# APPLICATION FOR AMENDMENT OF PLAN UNDER SECTION 12A OF THE TOWN PLANNING ORDINANCE (CAP.131)

For Official Use Only 請勿填寫此欄	Application No. 申請編號	Y/TP/37
	Date Received 收到日期	28 OCT 2022

(b) Full address/ location/ demarcation district and lot number (if applicable) 詳細地址／地點／丈量約份及地段號碼（如適用）	Lots Nos. 738 S.C. and 738 S.C. ss. 1 in D.D. 6 and adjoining Government Land, No. 74-75 Kam Shan Road, Tai Po, New Territories

Applicants	: Fancy Lotus Limited
Planning Consultants	: Vision Planning Consultants Limited
Project Architect	: Studio Raymond Chau Architecture Limited
Traffic Consultants	: MVA Hong Kong Limited
Date of Submission	: 26th October, 2022

**Figure 5**

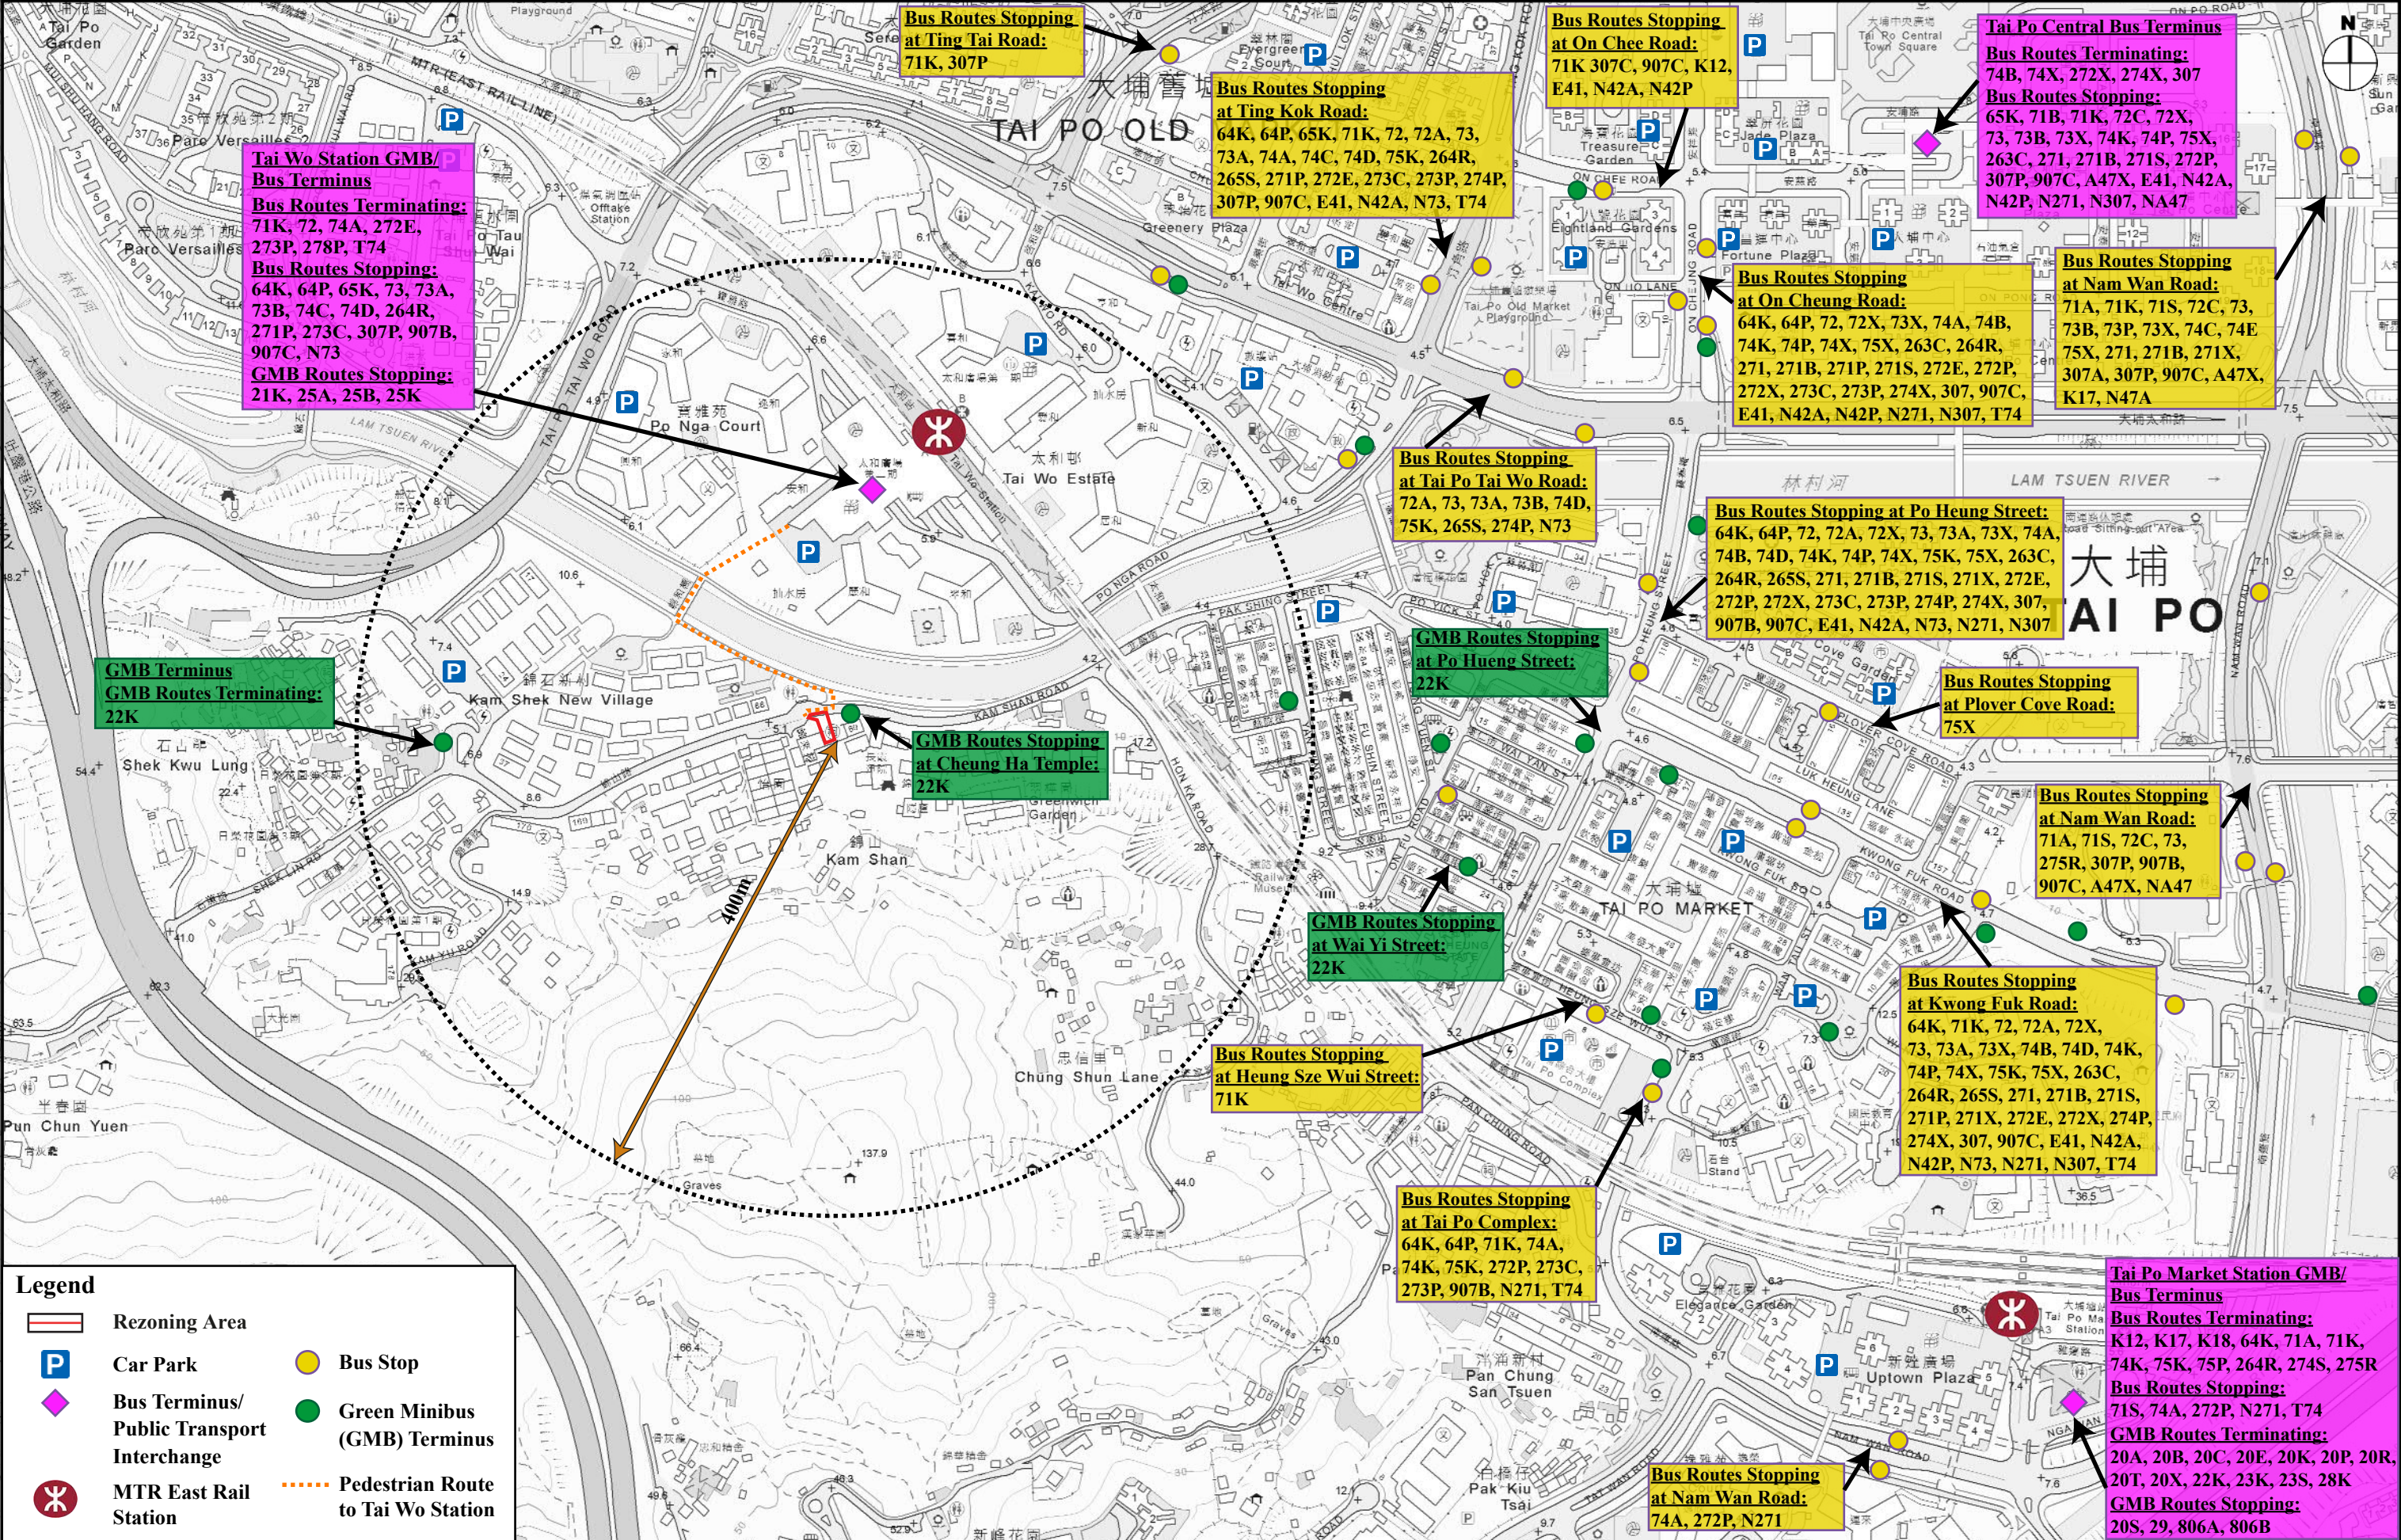
3.	Apart from above, we had spotted that the boundary of shaded rezoning	Noted. The site boundary in Figure 5 has been

area in figure 2 and figure 5 on the planning statement is inconsistent.	revised accordingly and has been attached in the Further Information (FI) submission dated 30.12.2022 ( <i>See Annex B</i> ).

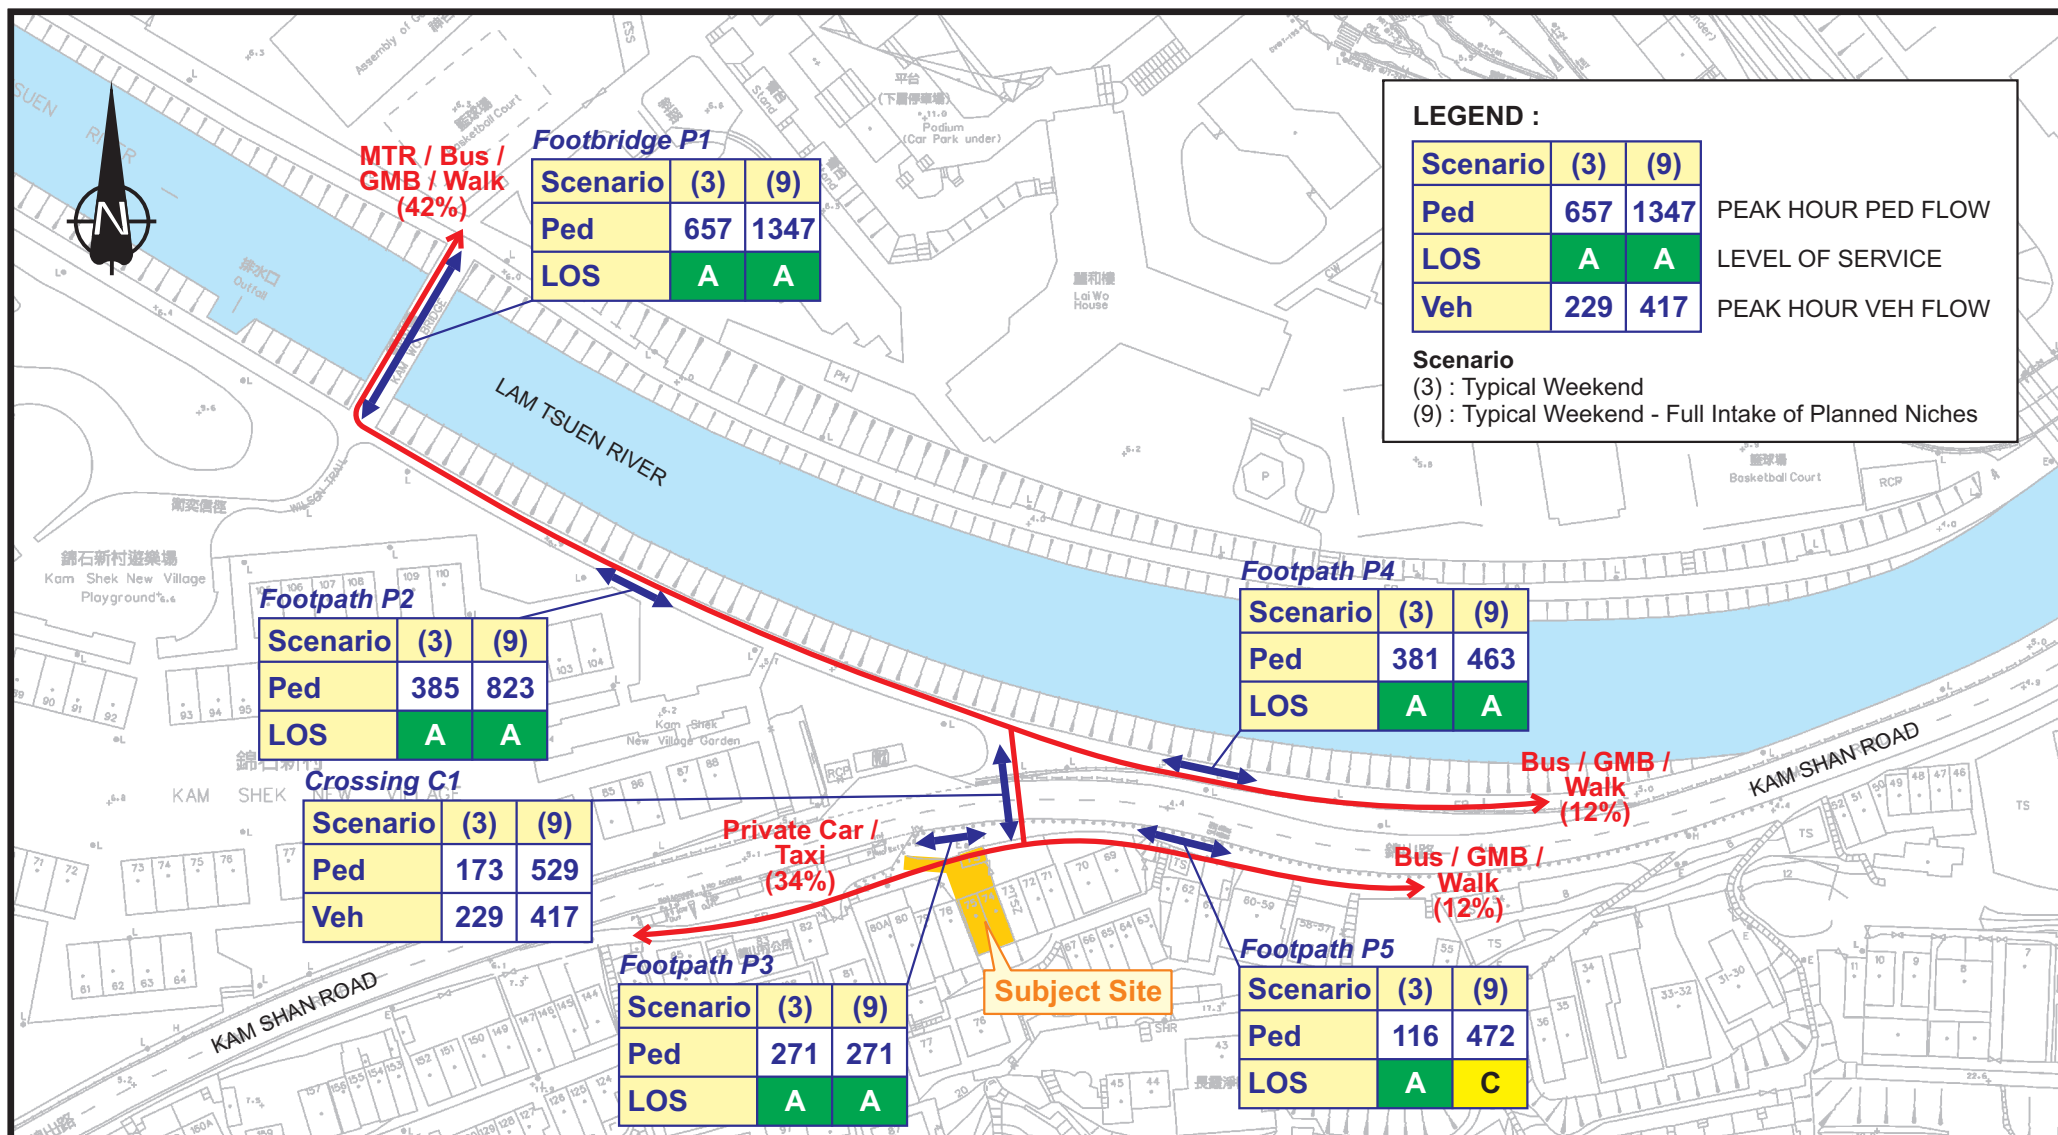
A RESPONSE TO TD'S COMMENT				B UPDATED TRIP RATES							
Rev.	Description	Checked	Date	Rev.	Description	Checked	Date	Rev.	Description	Checked	Date
Project Title				Drawing Title							
REZONING APPLICATION FROM "VILLAGE TYPE DEVELOPMENT" ZONE TO "GOVERNMENT, INSTITUTION OR COMMUNITY (3)" ZONE AT NOS. 74-75 KAM SHAN ROAD AND ADJOINING GOVERNMENT LAND, TAI PO, NEW TERRITORIES				YEAR 2028 DESIGN PEDESTRIAN FLOW AND LOS - SENSITIVITY TEST							
Designed		Checked		Scale		Date		Drawing No.		Rev.	
TLY		LHW		NTS		DEC 2022		D2		B
